**TRANSBAY JOINT POWERS AUTHORITY
BOARD OF DIRECTORS**

Resolution No. 23 - 007

Addendum to the Transbay Program 2018 Final Supplemental Environmental Impact Report

December 2022

Figure 2-12. Proposed Realigned Tunnel Stub Box

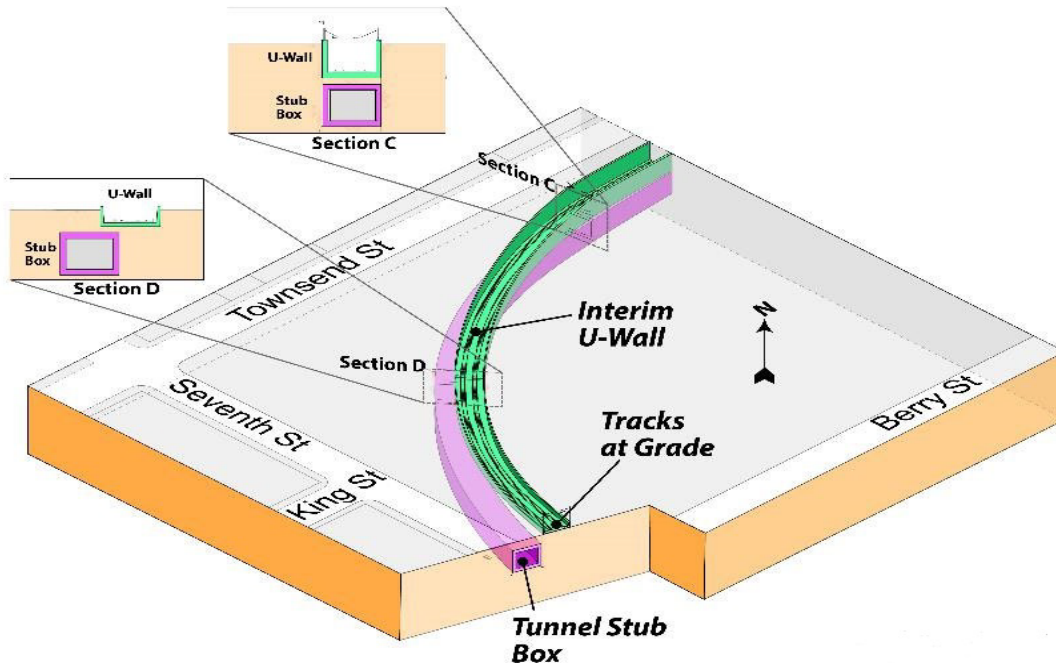
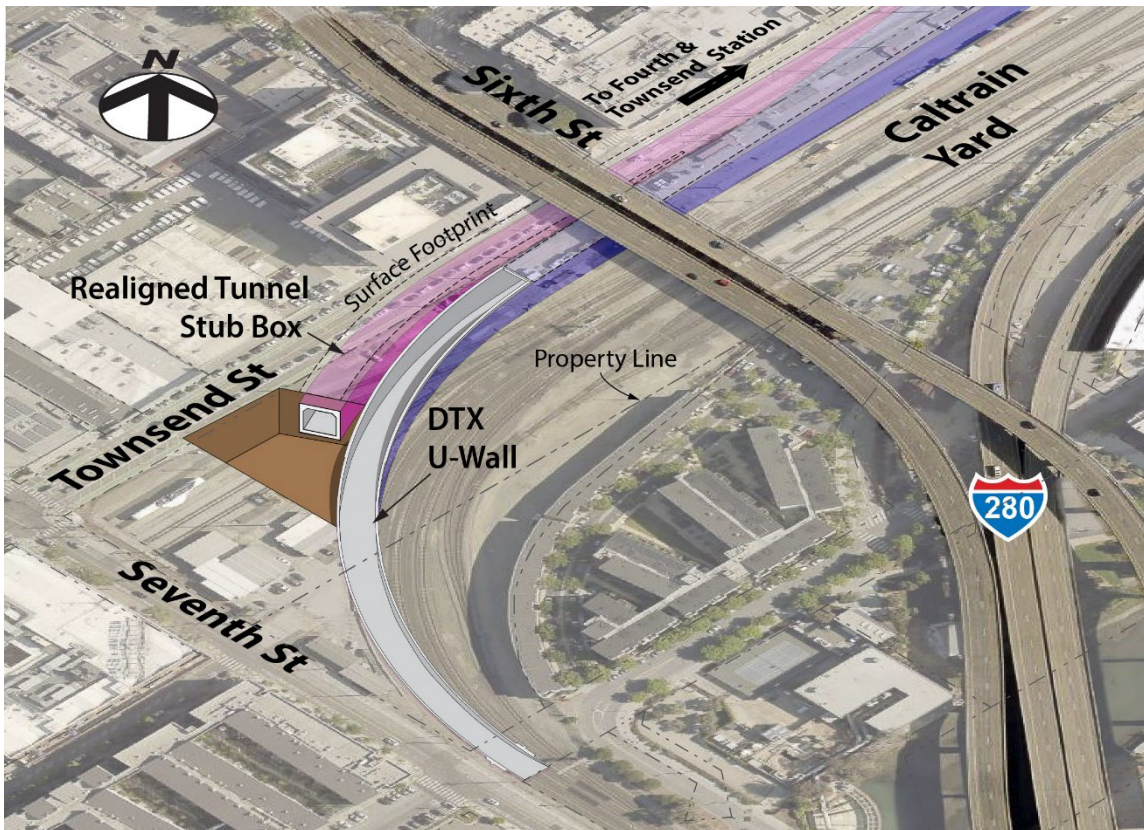
Description and Objective of Proposed Revision. In furthering design of the Fourth and Townsend Street Station and analyzing the operational impacts of the future grade separation tunnel, the tunnel stub box alignment has been refined. The modifications would alter its alignment so that it would be shorter, adjacent to the U-wall rather than underneath it, and partially underneath the Townsend Street right-of-way. The tunnel stub box would be underneath one-half of the width of Townsend Street between Fifth and Sixth Streets and underneath one traffic lane of Townsend Street between Sixth and Seventh Streets, for a total length of approximately 1,000 feet. Only the south side of Townsend Street adjacent to the Caltrain railyard would be affected by the realigned tunnel stub box (stub box shown in pink in Figure 2-12). During the cut-and-cover construction of the tunnel stub box, street-level decking would be laid on Townsend Street, to allow continued vehicular access. No modifications to the U-wall would be required to realign the tunnel stub box.

The proposed realignment of the tunnel stub box to be adjacent to the U-wall would enable both to be used at the same time. The U-wall would be available for trains to move from the railyard into the tunnel, and the tunnel stub box would provide access into the tunnel by a future underground connection for Caltrain and high-speed rail. The rationale for constructing the tunnel stub as part of the Revised Project is the same as presented in the 2018 Final SEIS/EIR; which is to support the future arrival of below-grade Caltrain and HSR service, and to preserve future options regarding grade separations. The proposed alignment would require less excavation than the approved project because of the shallower tunnel stub box. In addition, the proposed alignment of the U-wall and tunnel stub box would allow Caltrain service and movements between the railyard and the tunnel to continue with minimal disruption when the future underground connection is constructed through the western portion of the Caltrain railyard.

Figure 2-15. Proposed Reconfiguration of At-Grade Trackwork South of the Caltrain Railyard

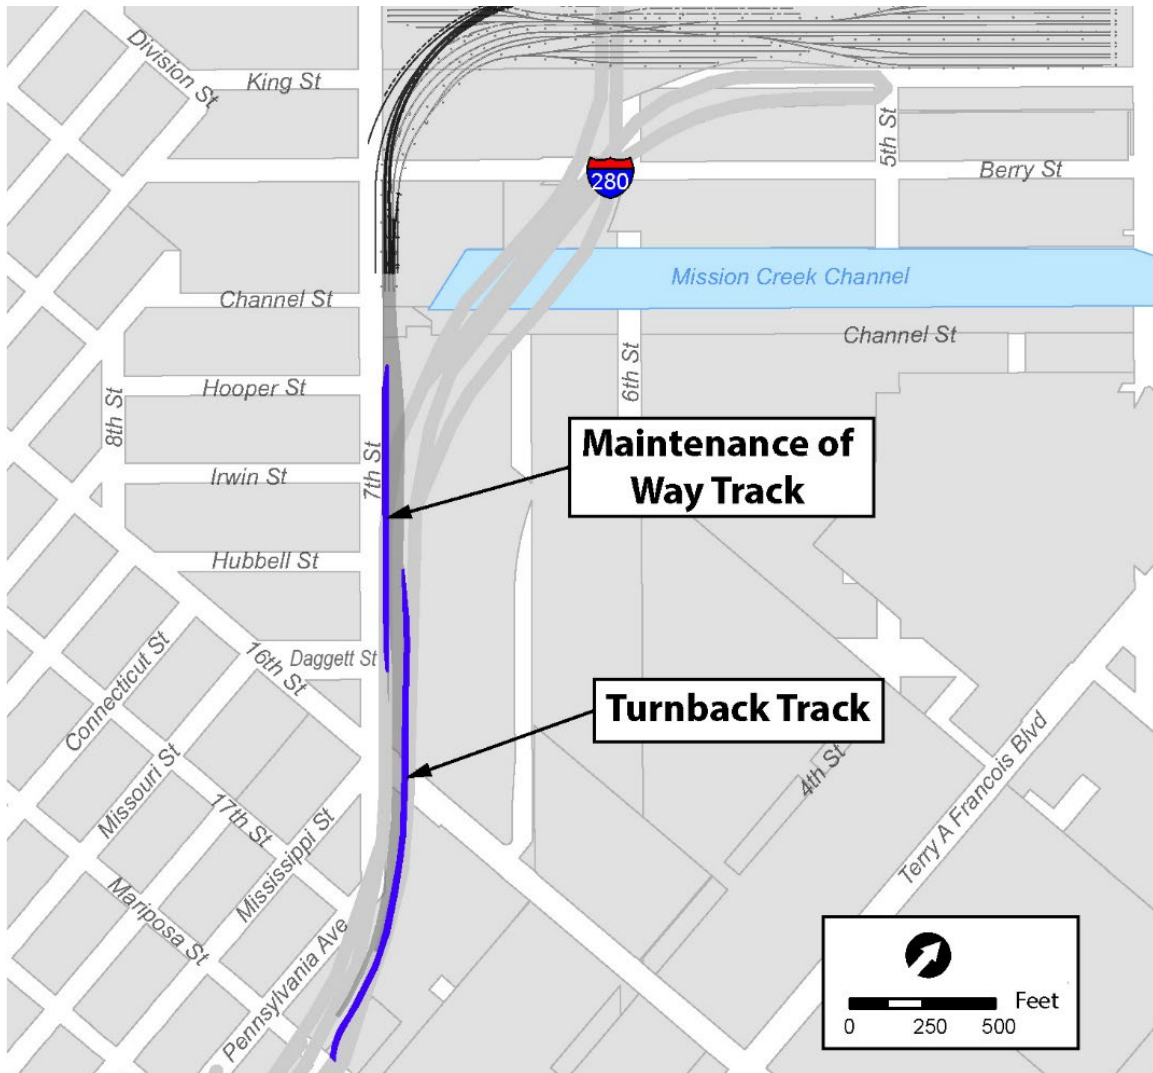
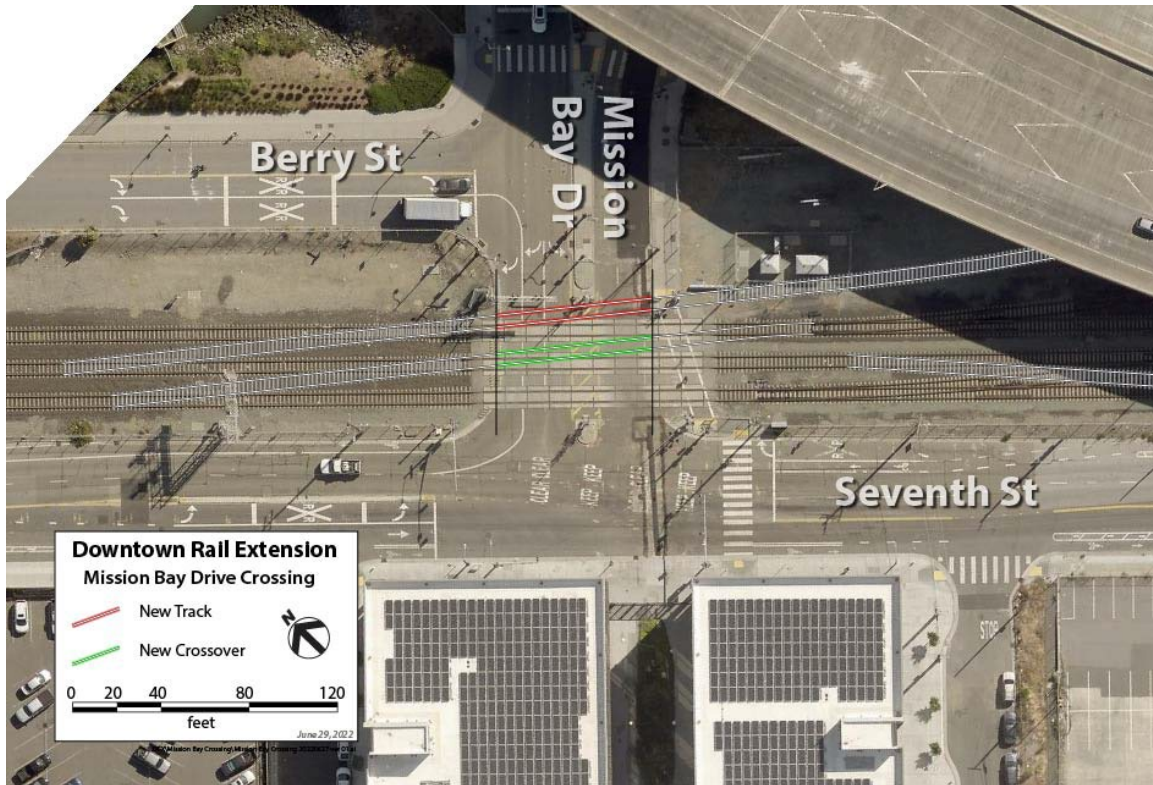
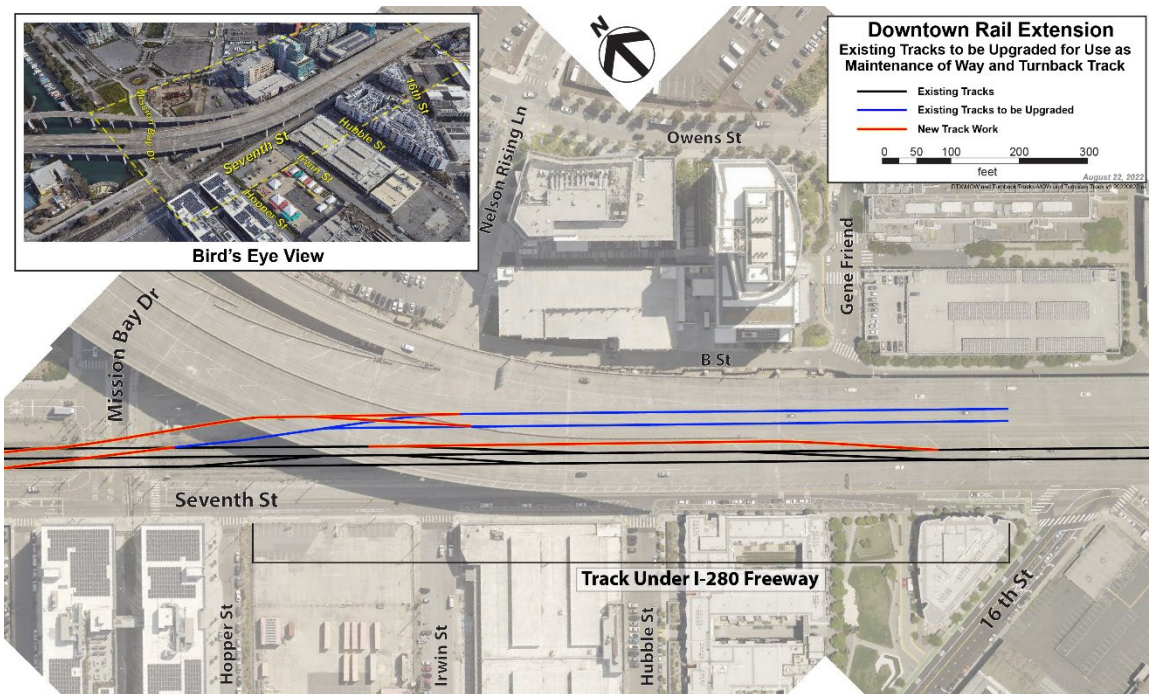
Description and Objective of Proposed Revision. In furthering the design of the at-grade trackwork south of the Caltrain railyard, the TJPA and Caltrain have agreed that relocating the MOW track from the west side of the mainline tracks to the east side, where

it would connect and run parallel to the turnback track, would allow more efficient train movement between the railyard and the Transit Center. This reconfiguration would include an additional track at the existing at-grade crossing of Mission Bay Drive within the Caltrain right-of-way (the red-colored track in Figure 2-14), resulting in four tracks at this crossing compared to the three existing Caltrain tracks. The additional, fourth track could be used to access either the MOW or turnback track. It would be at a slight angle (further from the other tracks at the south end) and would require moving the east side railroad crossing gate further east along Mission Bay Drive by approximately 9 feet. To facilitate train operations, a new crossover track also would be added between the existing tracks at the Mission Bay Drive crossing (the green-colored track in Figure 2-14). A crossover track is a special trackwork element that allows trains to move from one track to another as directed by the central train control dispatch and the signaling system. The westbound Mission Bay Drive vehicle signal stop line is east of Berry Street; signal timing along Mission Bay Drive at Berry Street is interconnected with the timing at Seventh Street and allows vehicle clearance on the track. The red-colored track (see Figure 2-14) would connect to two existing, MOW tracks on the east side of the Caltrain right-of-way that would be upgraded for use as a MOW or turnback track.

Trains would continue to use the existing tracks at the Mission Bay Drive grade crossing for routine revenue service, while use of the additional MOW/turnback track would occur only during off-peak hours. Caltrain is working to identify the number of off-peak movements for the additional track at Mission Bay Drive based on the Caltrain Business Plan.

In addition to the changes to the trackwork at Mission Bay Drive, another new track within the Caltrain right-of-way between existing tracks, from approximately just north of Irwin Street to just north of 16th Street, would be constructed to provide operational flexibility. This project modification was developed by TJPA in collaboration with Caltrain, and would, in conjunction with the additional track at Mission Bay Drive, eliminate the need for the turnback track to extend across 16th Street and continue to Mariposa Street. Figure 2-15 shows this new track, as well as the new track across Mission Bay Drive described above.
